## REPORT OF ALTERATIONS TO DESIGNATED RESOURCE

Site Number/Address: 511 Whedbee Street

Laurel School National Register Historic District

ISSUED: September 30, 2021

Rear Bldg. Elev. 1/4"=1'-0"

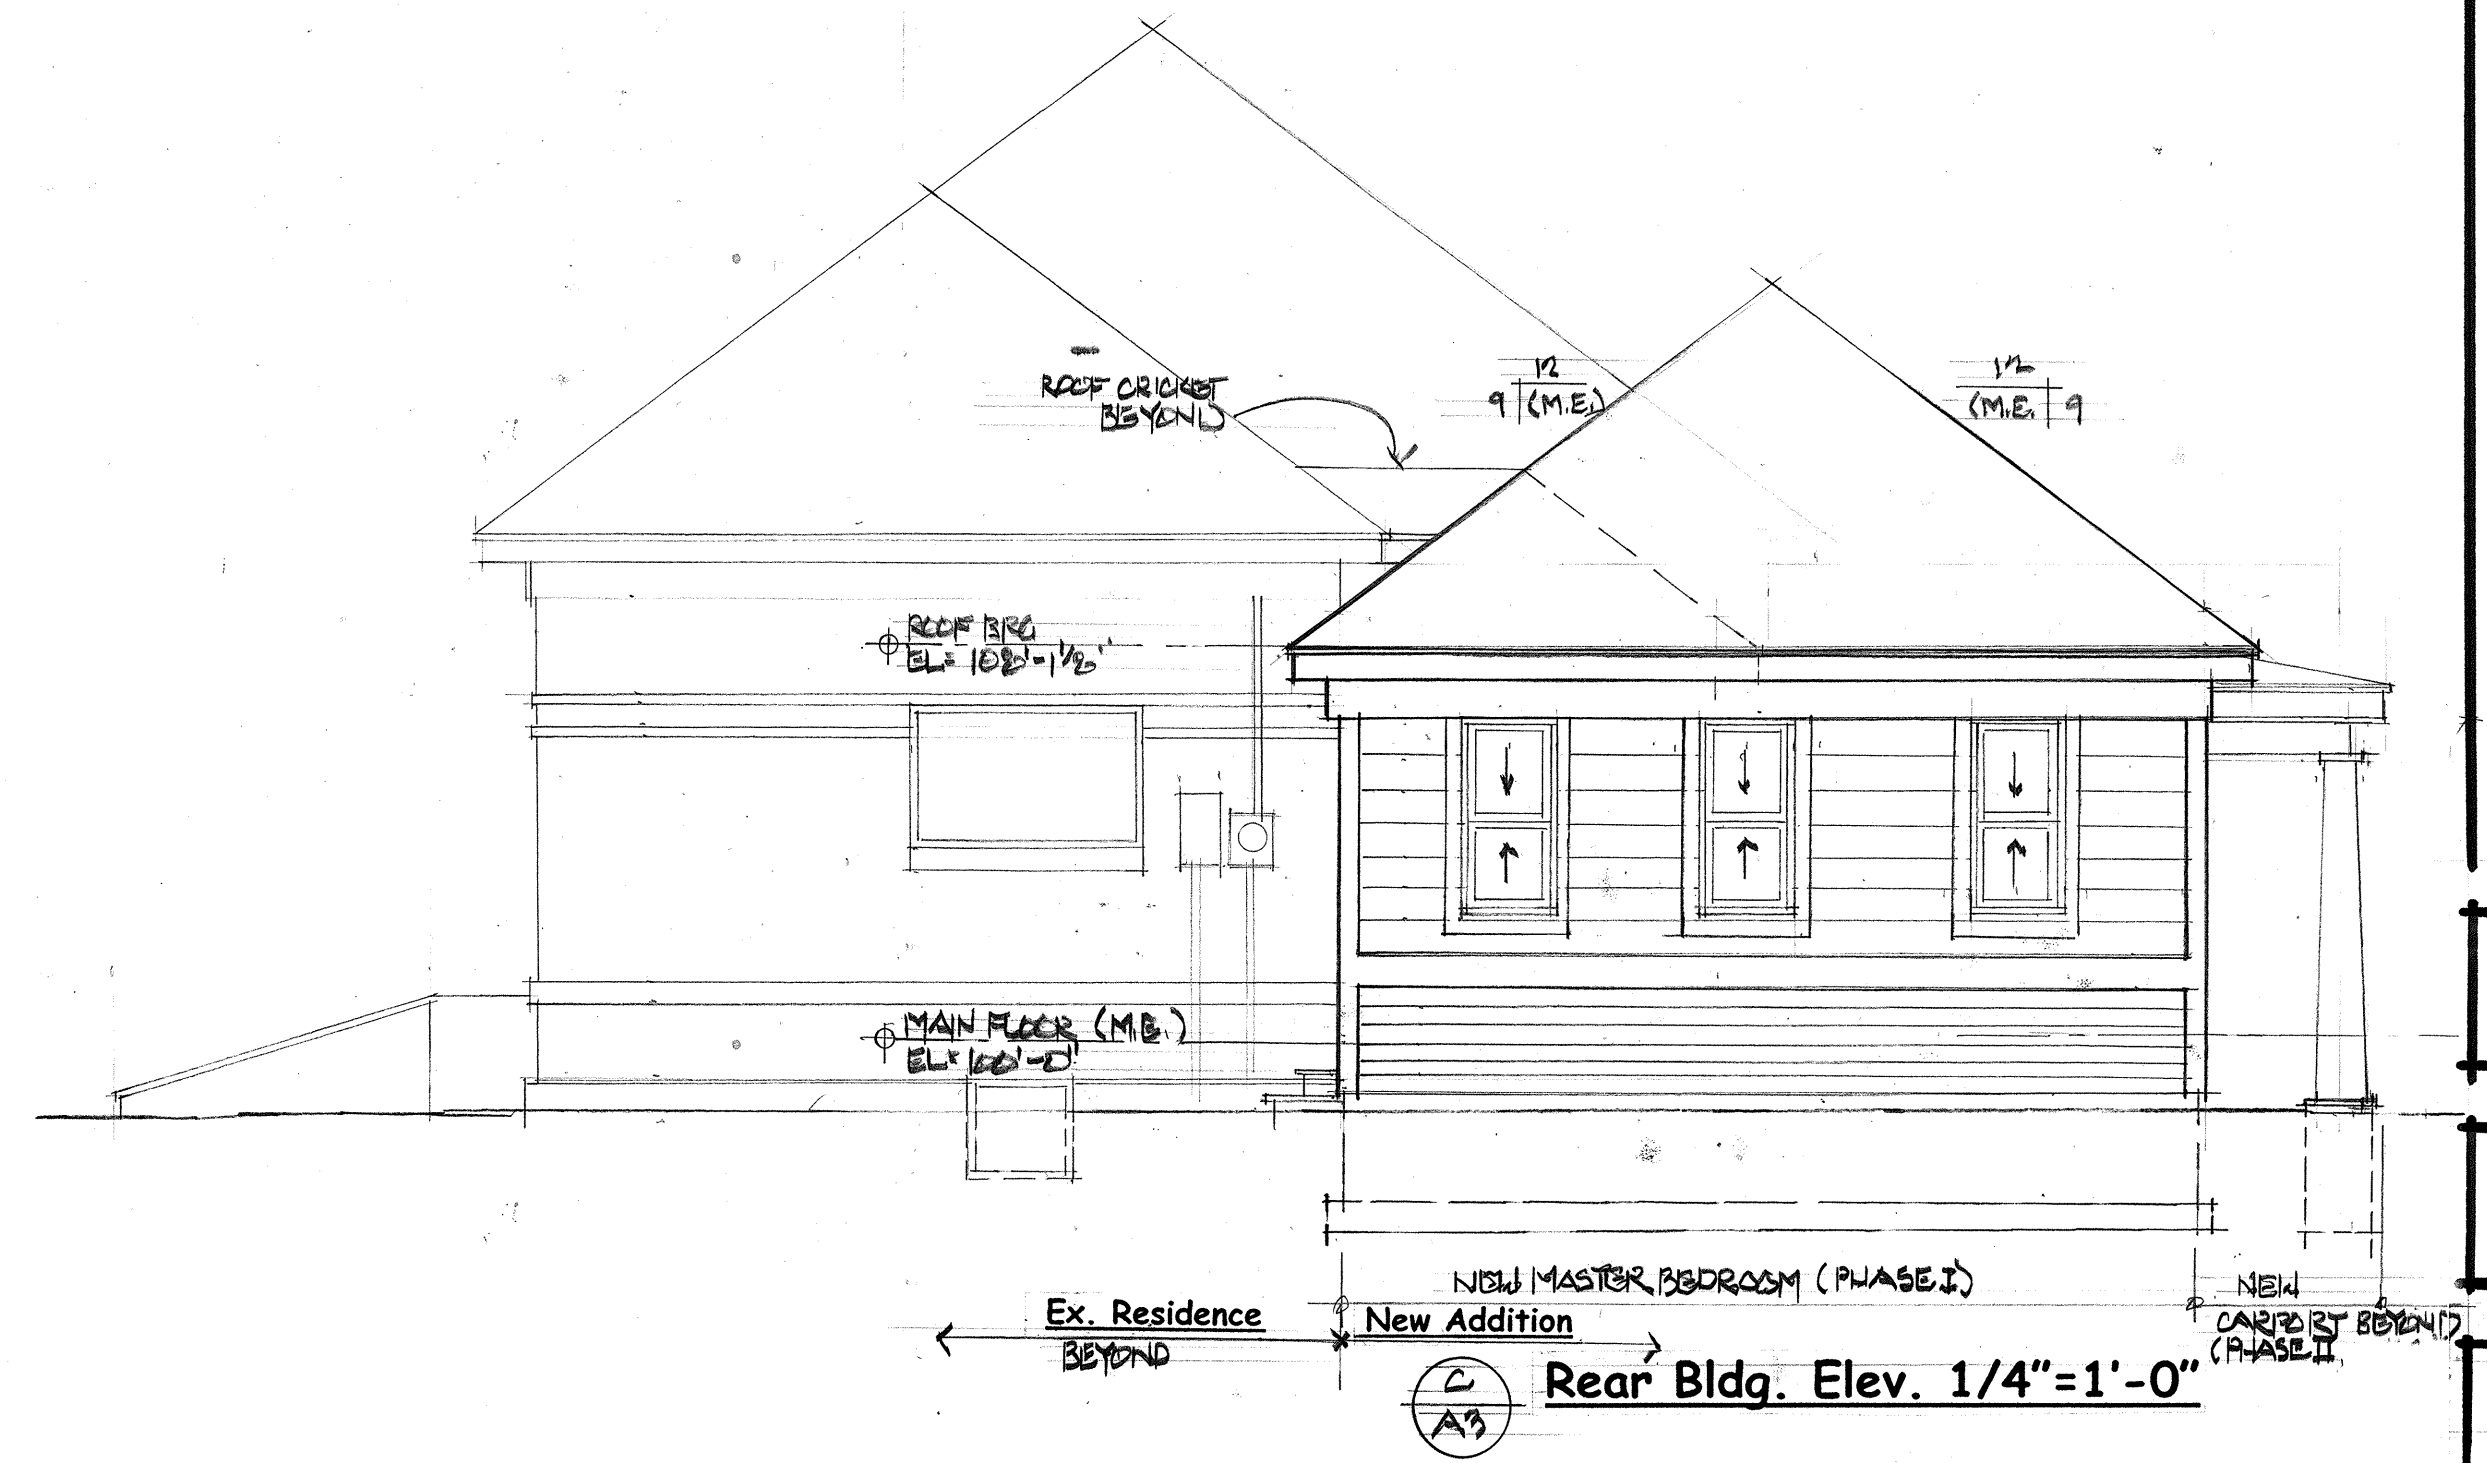
**Carport –** This modification does not meet this Standard. While porte cochere's were seen during the historic district's period of significance (c.1880-1940), they were highly uncommon in Fort Collins, even on residences for wealthier residents, because alley side garages and carriage houses were much more common ways to store wagons, carriages, and vehicles. The highly visible addition of a carport to the home's south elevation will disrupt the overall character of the property. It is not resulting in the removal of any historic features but will be highly noticeable and disrupt the simple design of the property as viewed from Whedbee Street.

<p><b>Carport – The carport addition onto the south elevation does not meet this Standard.</b></p> <ul style="list-style-type: none"> <li>- <b>Compatibility – the carport addition is not compatible with the overall design of the property. Carport/porte cochere features were almost never installed on homes of this size and type, and especially not in Fort Collins.</b></li> <li>- <b>Distinguishability – the carport addition further is not properly distinguishable as a new feature, creating a false sense of historical development through the use of Classical columns to support the feature.</b></li> <li>- <b>Subordination – In a residential context, side additions of any kind are generally discouraged under the Standards. In this case, the carport will extend to the front wall plane of the property and will be highly visible from Whedbee Street – it does not meet this Standard.</b></li> </ul>
